Access Compliance Report Public Rights-of-Way (Curb Ramps)

Intersection ID: 17673 Main Street: MONROE_RD **Cross Street: OLD POST RD** Location: SE ADA ID: 235FD9BCE4F1 **Overall Compliance: No** Ramp Type: Directional1 Initial Pass/Fail: Pass **Severity Score:** 0.25

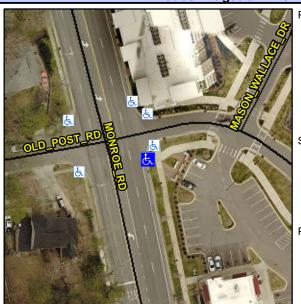
Possible Solutions:						
Remove & Replace Entire Ramp.						
•						
Surveyor Notes:						
N/A						
PROW/ADA:						
R304.5.3

Comp	liance Description	Data	Comp	liance Description	Data
N/A	Ramp Length (in)	66.0	Yes	Grade Break?	Yes
Yes	Ramp Width (in)	93.0	Yes	Grade Break Slope (%)	1.0
Yes	Ramp Slope (%)	1.4	Yes	Grade Break XSlope (%)	0.2
No	Ramp XSlope (%)	2.8			
Yes	Flare Type LT	N/A	Yes	Flare Type RT	N/A
N/A	Flare Slope LT (%)	N/A	N/A	Flare Slope RT (%)	N/A
N/A	Flare Traversable LT?	No	N/A	Flare Traversable RT?	No
Yes	Landing Length (in)	90.0	Yes	DWS Provided?	Yes
Yes	Landing Width (in)	107.0	Yes	DWS Contrast?	Yes
Yes	Landing Slope (%)	0.9	Yes	DWS Length (in)	24.0
Yes	Landing X Slope (%)	0.3	Yes	DWS Full Width?	Yes
N/A	Landing Curb? (Y/N)	No	Yes	DWS Offset LT (in)	1.0
N/A	Shared Landing?	Yes	Yes	DWS Offset RT (in)	17.0
Yes	Gutter Ponding?	No	Yes	Gutter Slope (%)	1.0
Yes	Gutter Lip Ht (in)	0.0	Yes	Gutter X Slope (%)	1.9
N/A	Painted X Walk1?	No		Road Slope (%)	2.
	X Walk 1 Direction	To W		Road X Slope (%)	1.0
	X Walk 1 Width (in)	N/A	l	Clear Space?	Yes
